**Preliminary and Final Major Site Plan # 499-2-20 and
Variance Application # 009-20
500 Halls Mill Holdings, LLC
Block 78.02 Lots 8 & 8.01 – 500 Halls Mill Road**

RE: 500 Halls Mill Holdings LLC
Block 78.02, Lot 8.01
500 Halls Mill Road
Amended Preliminary and Final Major Site Plan #499-2-20 and Variance #009-20
REVIEW #2

500 Halls Mill Holdings, LLC
Block 78.02 Lots 8 & 8.01 – 500 Halls Mill Road
Site Plan # 499-2-20, Variance # 009-20
Sanitary Sewer and Water Systems Review #2

**Re: 500 Halls Mill Holding, LLC
Block 78.02, Lots 8 & 8.01
SP# 499-2-20
Drainage and Landscape Review No. 2**

HYDRANT DETAIL

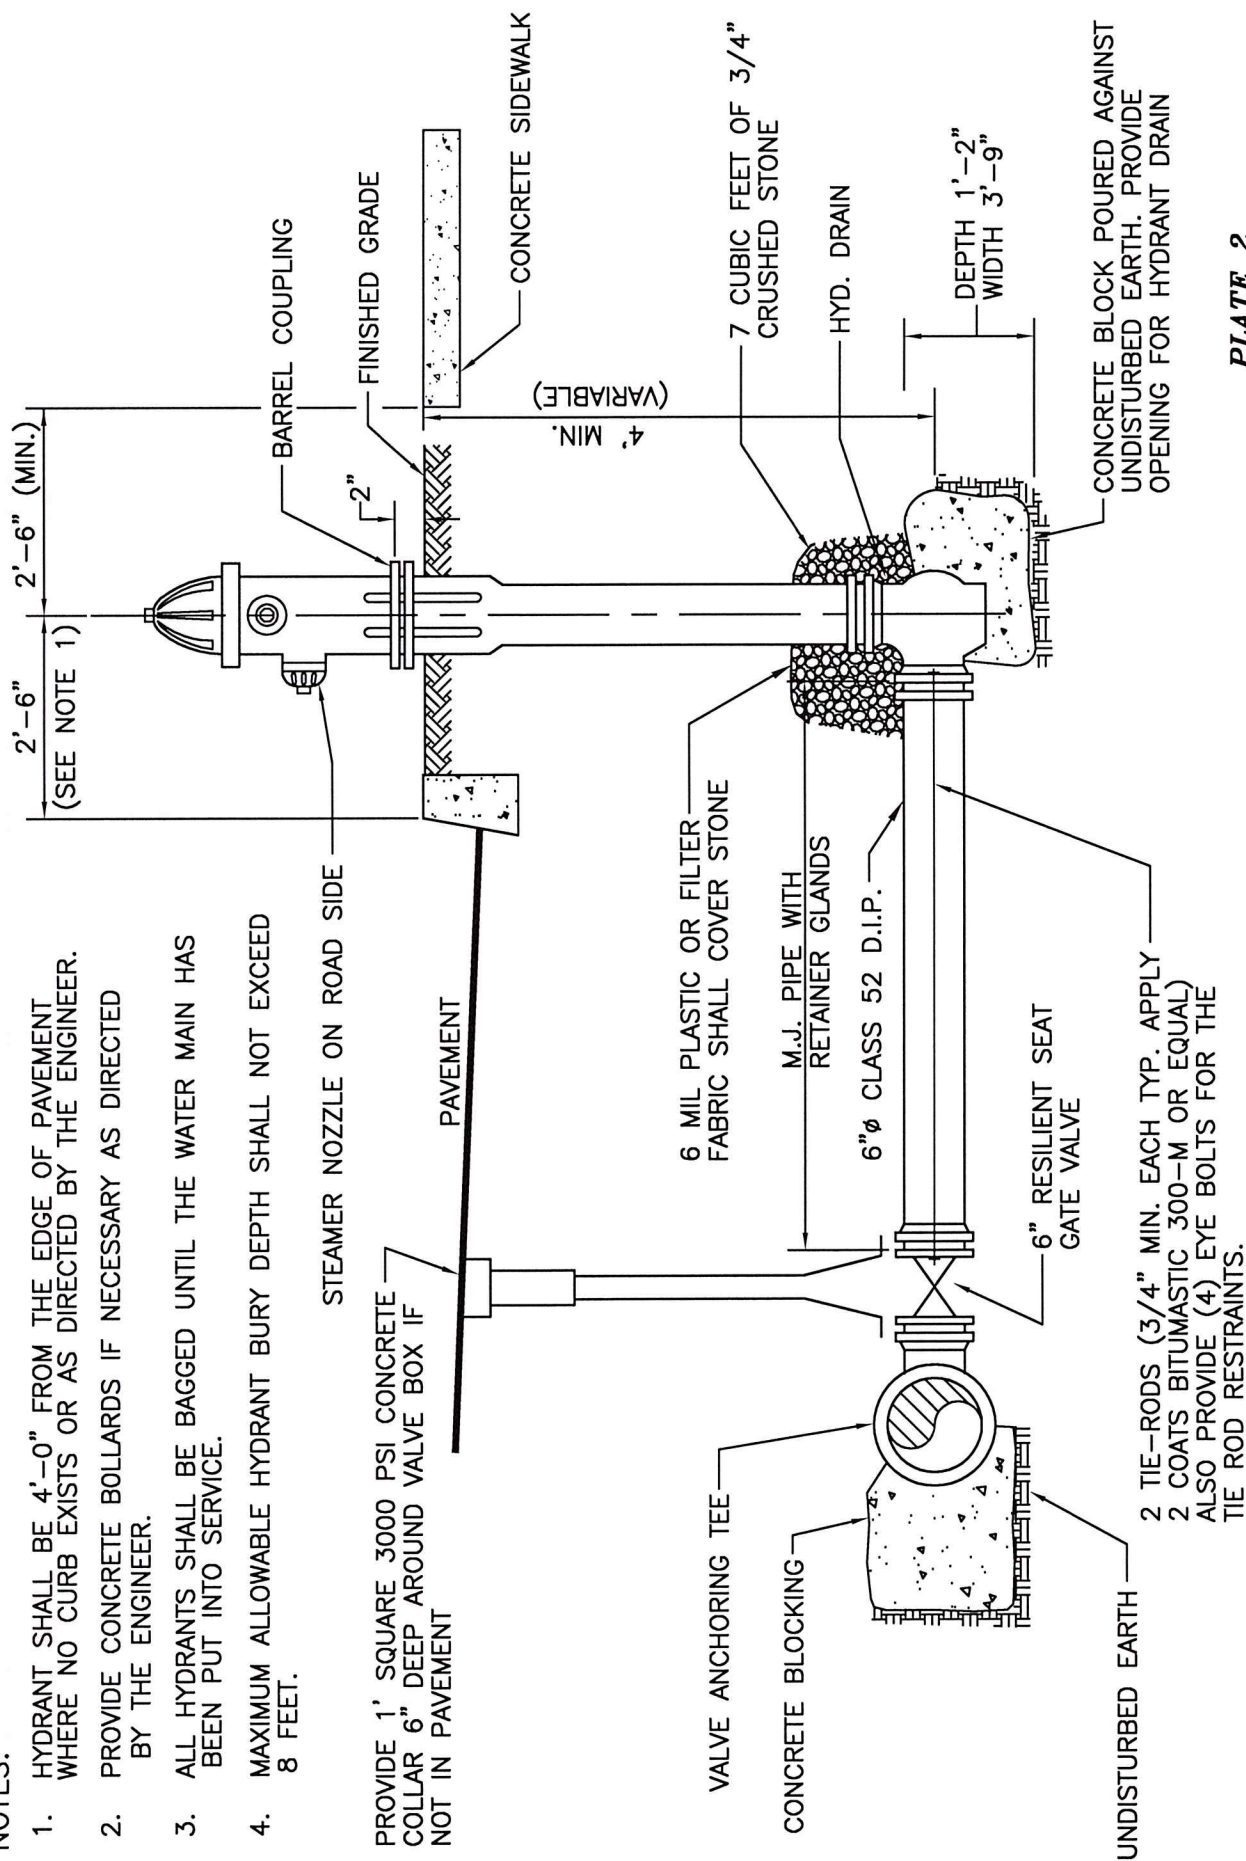
5. The following water main details which conform to the Township of Freehold Water Main Construction Standards should be provided on the construction detail sheets:

- a. Plate 2: Hydrant Detail
 - b. Plate 5: Buried Valve Detail
6. Final approval should be contingent upon the Township Fire Code Official and the Township Plumbing Code Official.
